JOHN C. MAXWELL
GEOLOGIST
5322 WESTERN HILLS DRIVE
AUSTIN, TEXAS 78731

March 7, 1988

Dr. Chester P. Siess
Advisory Committee on Reactor Safeguards
H Street
U. S. Nuclear Regulatory Commission
Washington, D. C. 20555

**SLIP RATES OF FAULTS
IN COASTAL CENTRAL CALIFORNIA**

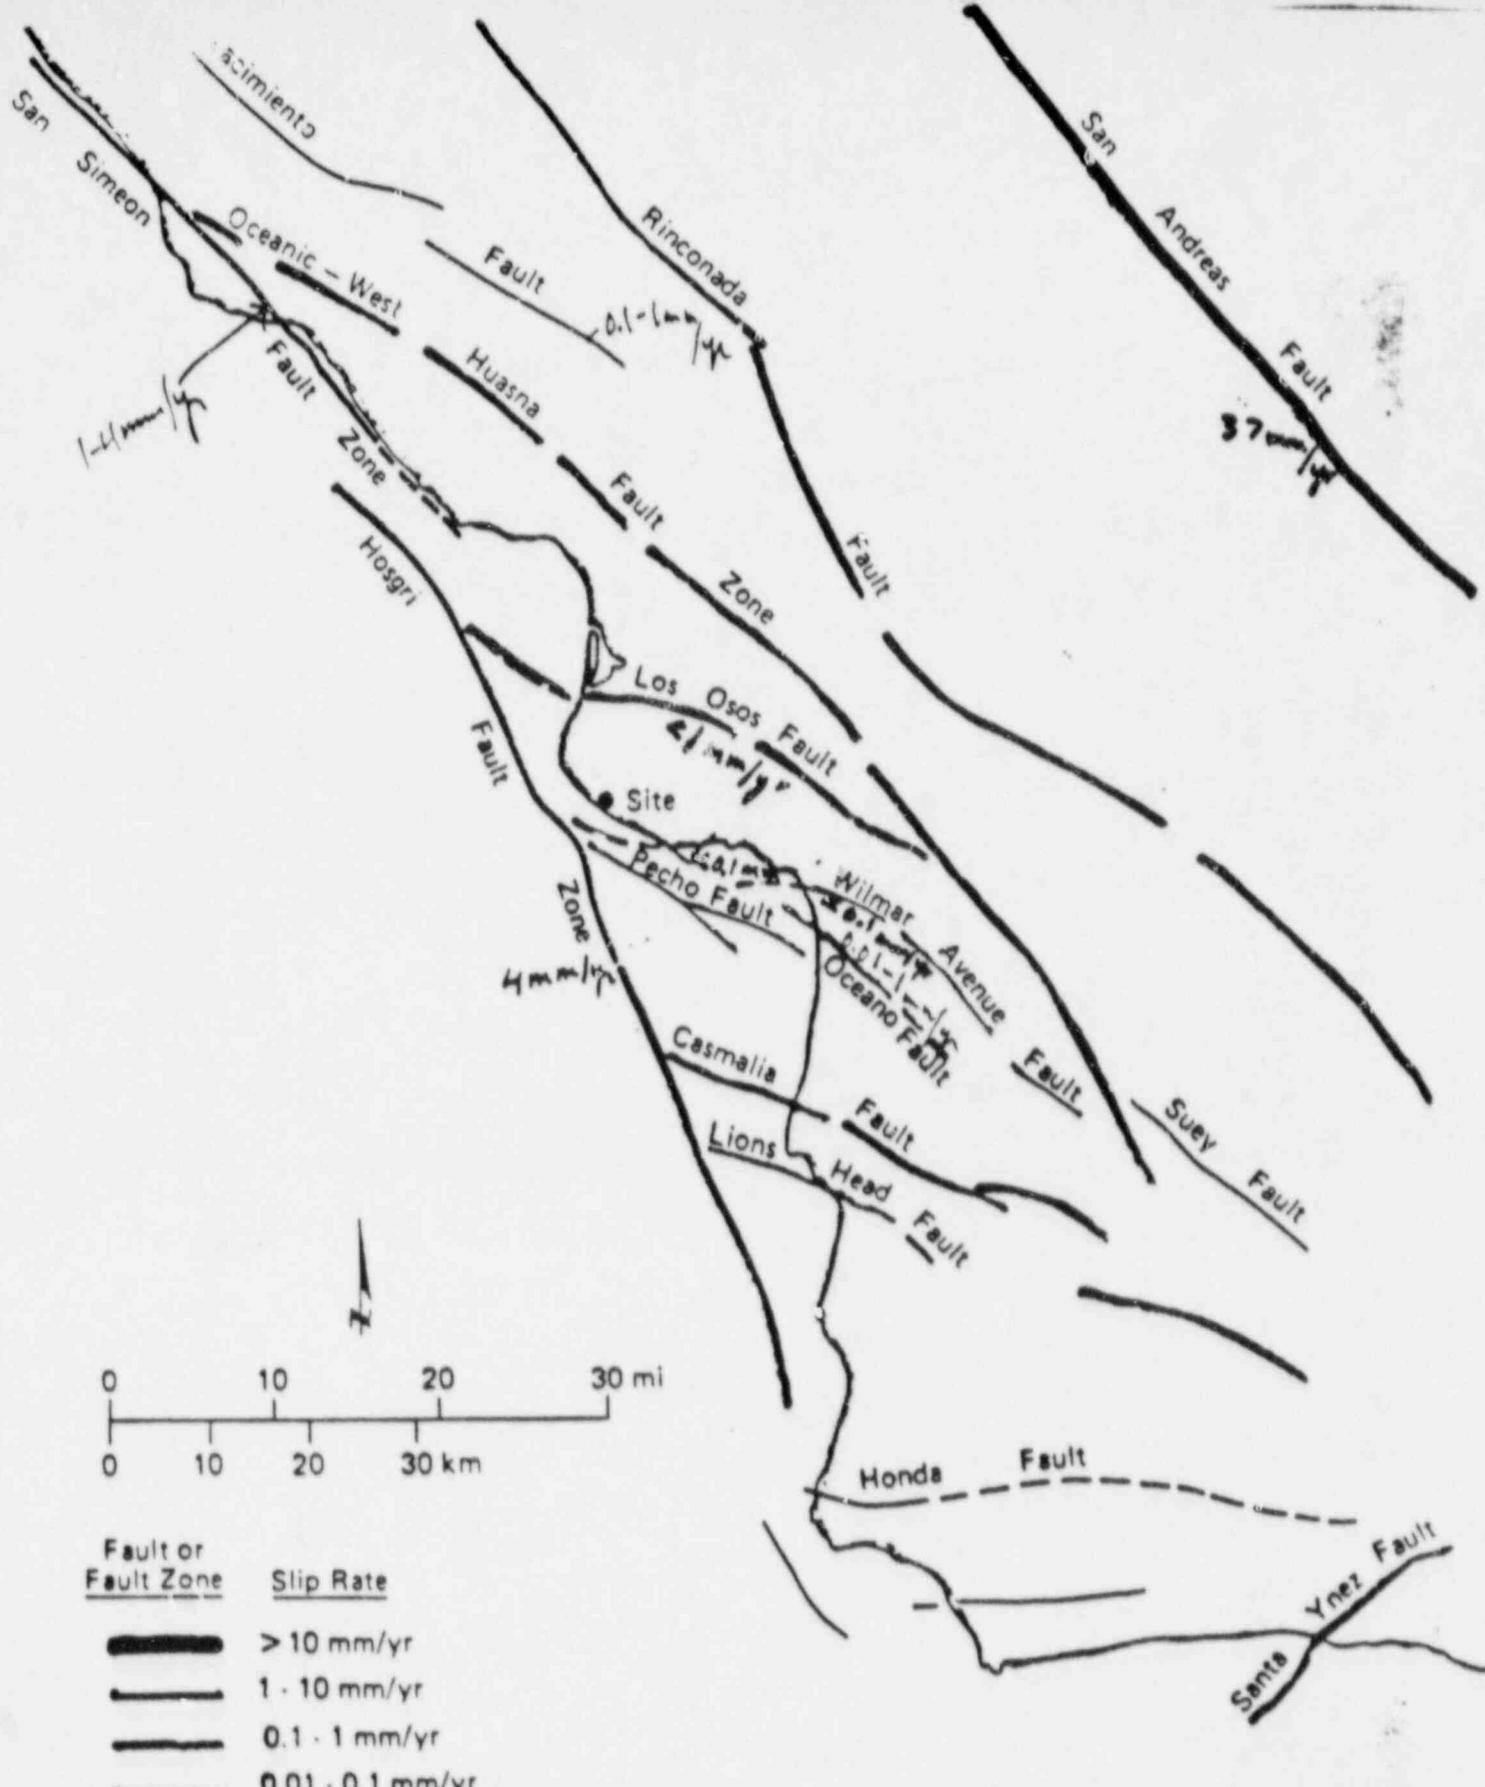
The P.G.&E. study classifies active faults in four categories, having annual slip rates which vary by four orders of magnitude. (See attached handout from 2-23-1988 subcommittee meeting in San Francisco). Over half of the 5 to 6 cm/year of shearing motion between the Pacific and North American plates, and a proportional release of seismic energy, occurs along the San Andreas fault system, which is

characterized by magnitude 8+ earthquakes. The next lower category includes the Hosgri, West Huasna and Rinconada strike slip faults. These faults, characterized by annual movement rates less than one centimeter and by earthquakes to magnitude 7+, release most of the seismic energy in the coastal area of the plant site. Faults with smaller slip rates should not produce earthquakes larger than 6+. The proportionality between fault length, slip rate and characteristic maximum earthquake seems to be valid for strike slip faults. A similar relation may be recognizable among dip slip faults, but the two types cannot be compared on the basis of fault length. In recent years several damaging earthquakes in central and southern California have occurred on faults which do not reach the surface, or are poorly exposed and unrecognized.
